# Updated Compressor Design: 6511696

TECH TIP

#203

gpd now offers an updated compressor design for 6511696 for:

## UPDATED DESIGN

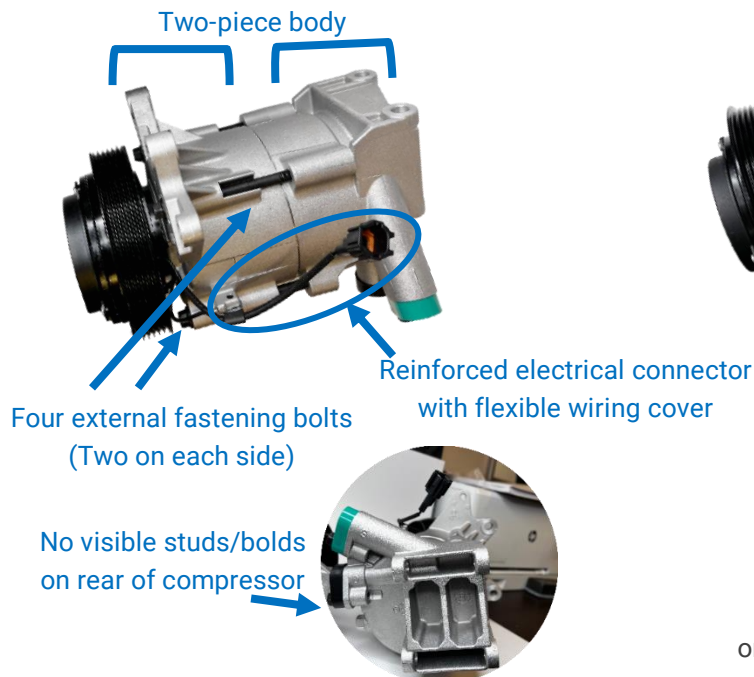
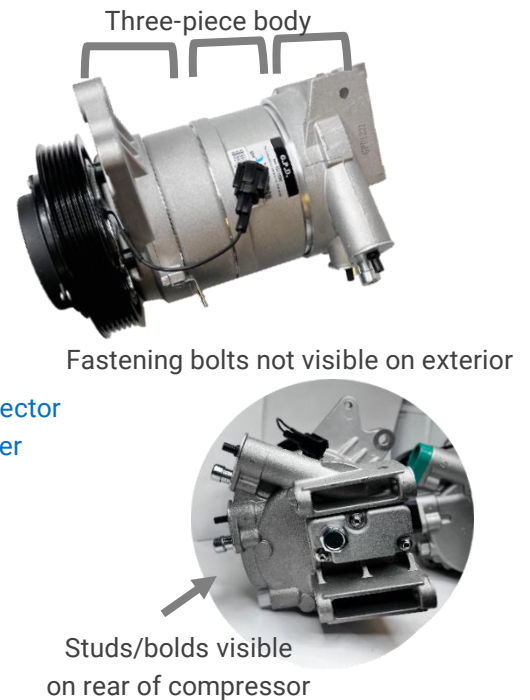
- Reinforced electrical connector with flexible wiring cover
- Two-piece body design vs. previous three-piece body design
- Four exterior body bolts vs. previous body design with five interior bolts
- Rear redesigned to protect rear studs/bolts

Redesigned as a two-piece body with four external fastening bolts.

External appearance matches OE design.
